DPR 25-21: Mo' Bettahs

Planning & Building Department Staff Report

For Hearing on February 23, 2026

A. PETITION NUMBER	DPR 25-21: Mo' Bettahs
B. APPLICANT	Savory MB Stores LLC, c/o Will Scott, PGAL
C. LOCATION	8894 East U.S. Highway 36, Avon IN 46123 Lot 5 in Harvest Landing

Exhibit E – Existing & Proposed Building Elevations (South & North)

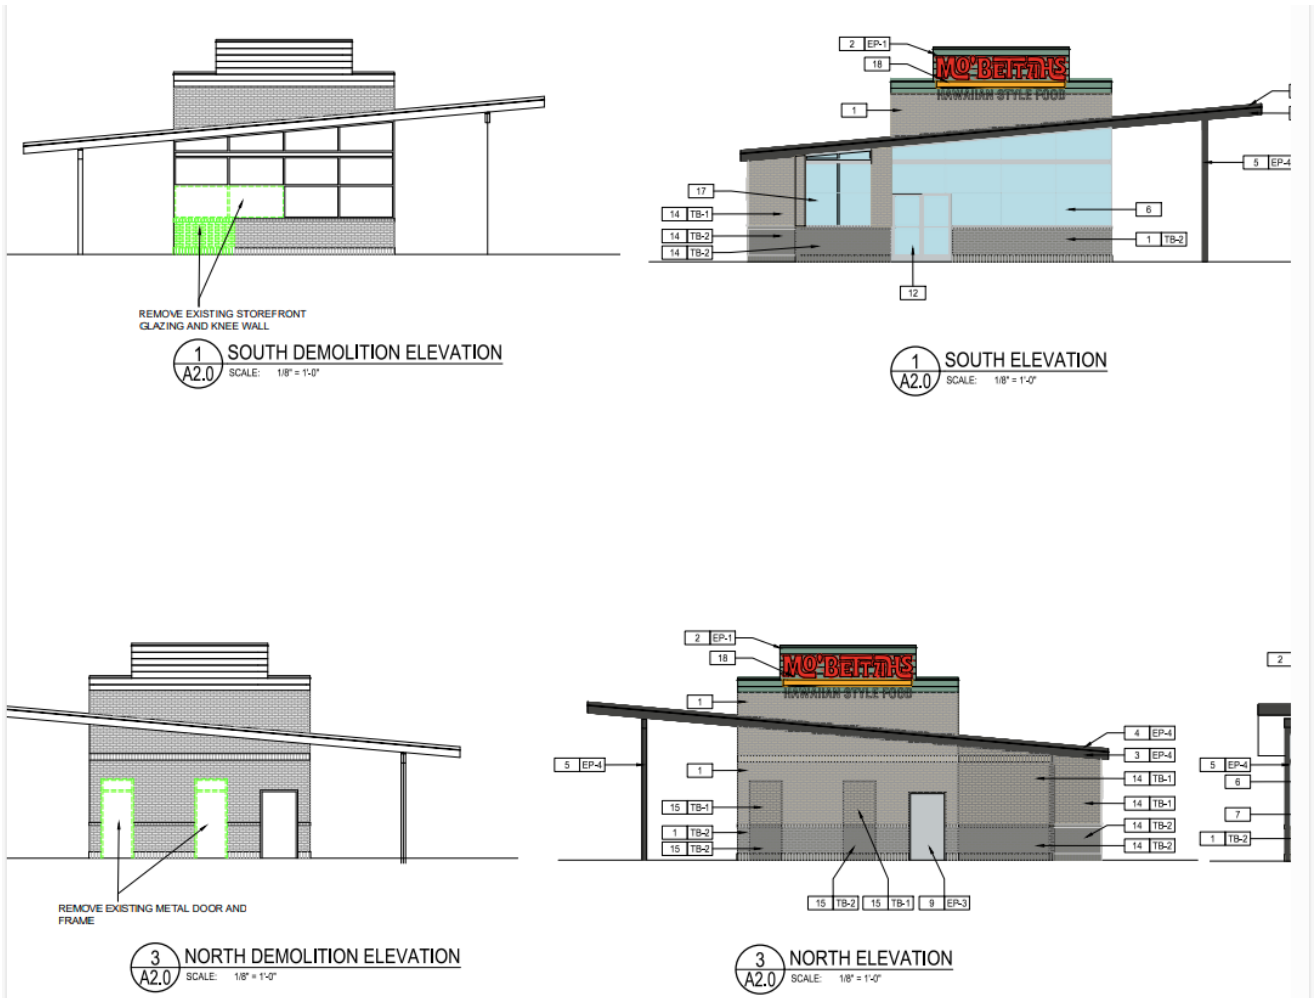
The revised building elevations submitted subsequent to TAC review appear to meet both the general architectural standards of UDO 7.10 as well as the additional U.S. Highway 36 overlay requirements found in UDO 2.10(O), except for the waiver for use of "thin brick", which is addressed below.

Waiver of Design Standards of UDO 7.10(I)(1), to allow for the use of “thin brick” siding (brick less than four inches thick not permitted).

“Thin brick” was not a prohibited material when the building was approved in 2022. Using additional thin brick to match the remainder of the existing building which is now legally nonconforming should not harm the public or adjacent properties.

Staff agrees that matching the existing exterior material is reasonable and preferable to using a permitted material that might not blend well aesthetically, and that it would be unreasonable to expect the petitioner to replace the existing siding material that is only a few years old.
